**SUBJECT: SPLIT SAMPLING OF CONTAMINATED GROUNDWATER**

On behalf of the Nuclear Information and Resource Service (NIRS) and the Union of Concerned Scientists (UCS), I am writing to you about the NRC's split sampling program as it is being administered for the contaminated groundwater at Braidwood.

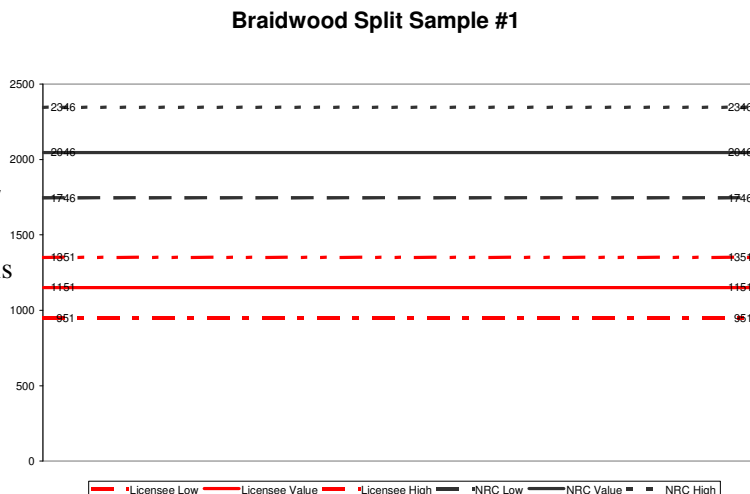
**Reasonably consistent? Hardly.**

The first split sample is so inconsistent that the uncertainty bands don't even overlap as clearly illustrated in the graphic. **The NRC's point value is 77 percent higher than the licensee's point value.** If the NRC's split sample here is "reasonably consistent" with the licensee's results from the same sample of water, than it would be equally reasonable to assume that every result reported by exelon could really be doubled.
